CONTRACT CHANGE ORDER NO. _____
SHEET ___ OF ___

MARK	DATE	DESCRIPTIONS	BY	CH'D	CCO#
2	04/08/11	SUSPENSION CABLE MISCELLANEOUS DETAILS	GB	MN	185
1	01/28/11	MISCELLANEOUS CABLE SYSTEM DETAILS	GB	MN	37S1

SAN FRANCISCO OAKLAND BAY BRIDGE
EAST SPAN SEISMIC SAFETY PROJECT
SELF-ANCHORED SUSPENSION BRIDGE
(SUPERSTRUCTURE & TOWER)
EAST CABLE ANCHORAGE "E" LINE LAYOUT NO. 2

EAST CABLE ANCHORAGE DETAILS

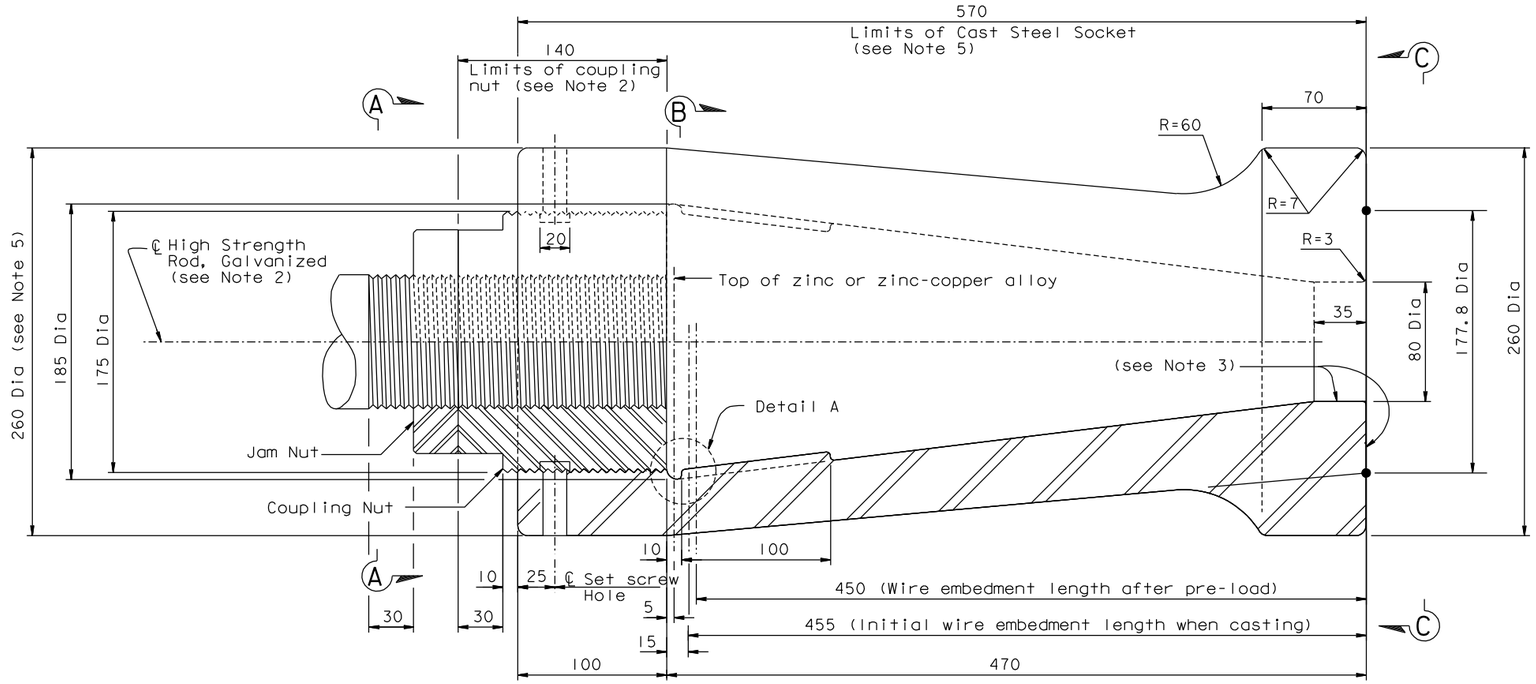
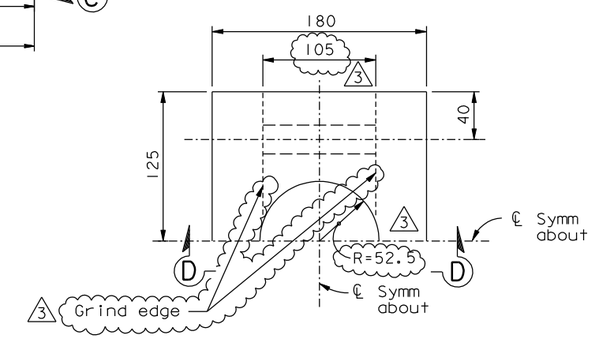
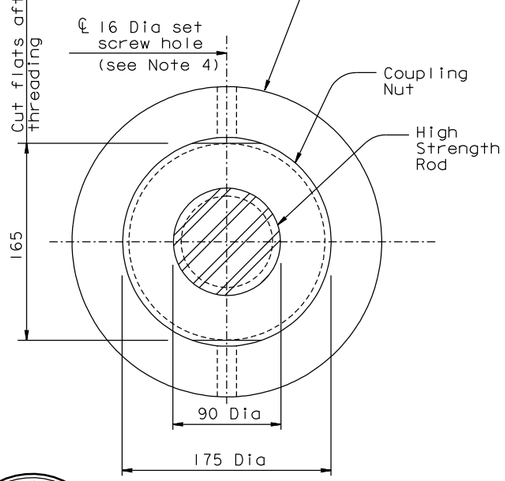
MARK	DATE	DESCRIPTIONS	BY	CH'D	CCO#
3	04/08/11	SUSPENSION CABLE MISCELLANEOUS DETAILS	DT	GB	185
2	01/28/11	MISCELLANEOUS CABLE SYSTEM DETAILS	DT	GB	37S1
1	08/28/09	BEARING BLOCKS	DT	GB	78

SUSPENSION CABLE MISCELLANEOUS DETAILS NO.1

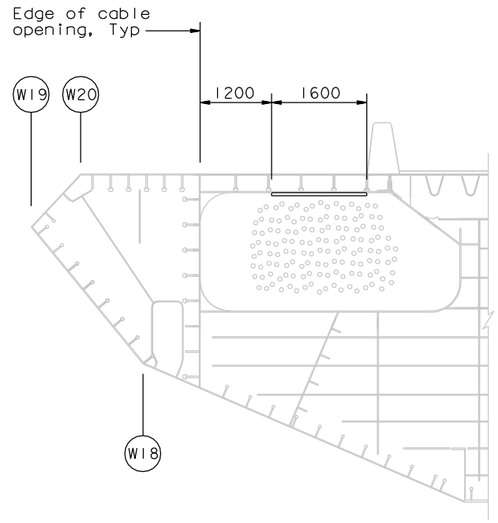
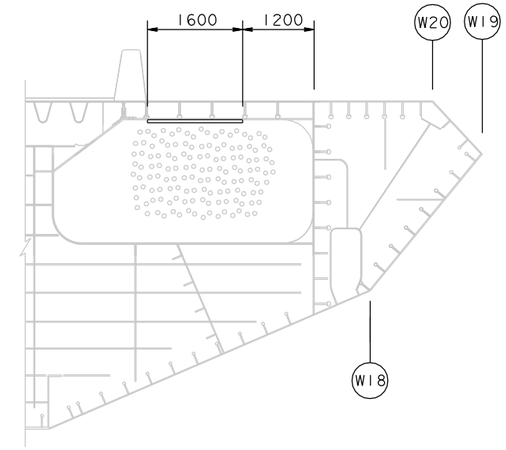
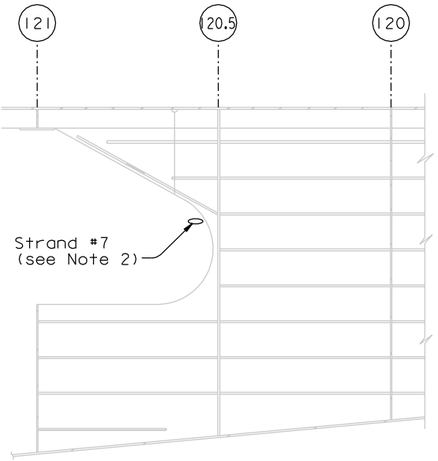
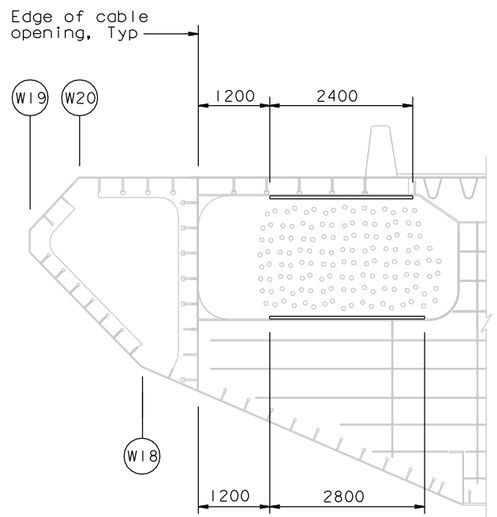
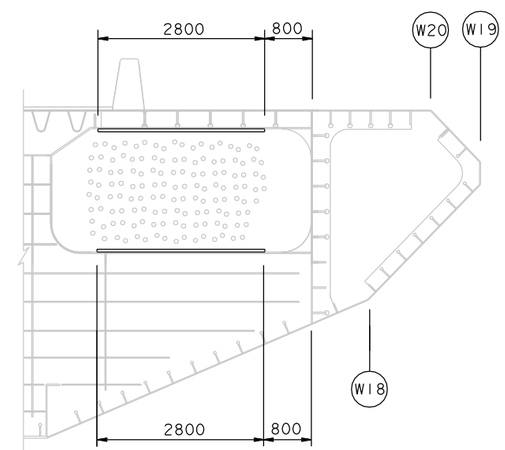
1. For details of neoprene pad at cable opening flanges, see "Suspension Cable Miscellaneous Details No.6" sheet.
2. Strand #7 shall be wrapped in the vicinity of the K plate per the "PWS Strand Sheathing" detail on "Suspension Cable Miscellaneous Details No.4" sheet.

MARK	DATE	DESCRIPTIONS	BY	CH'D	CCO#
1	02/08/11	SUSPENSION CABLE MISCELLANEOUS DETAILS	MN	GB	185

SUSPENSION CABLE MISCELLANEOUS DETAILS NO.2

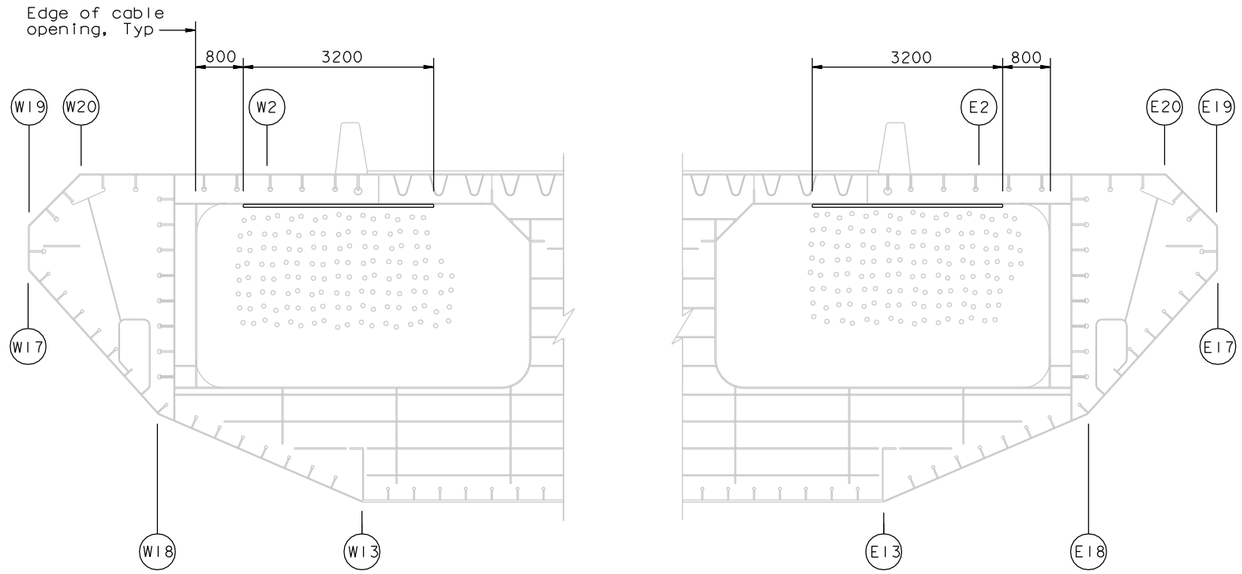
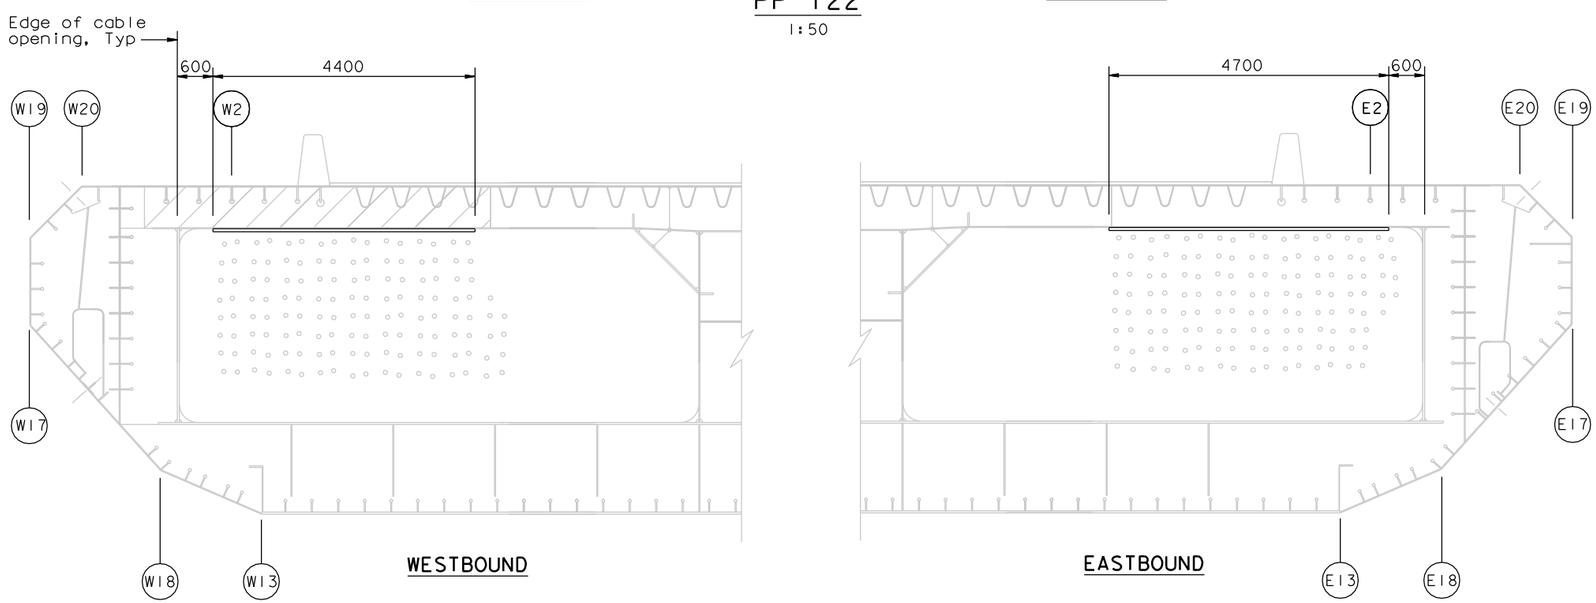
1. For details of neoprene pad at cable opening flanges, see "Suspension Cable Miscellaneous Details No.6" sheet.
2. Protection for PWS strands is not required at PP 122.5 (EB & WB).

MARK	DATE	DESCRIPTIONS	BY	CH'D	CCO#
0	02/08/11	SUSPENSION CABLE MISCELLANEOUS DETAILS	MN	GB	185
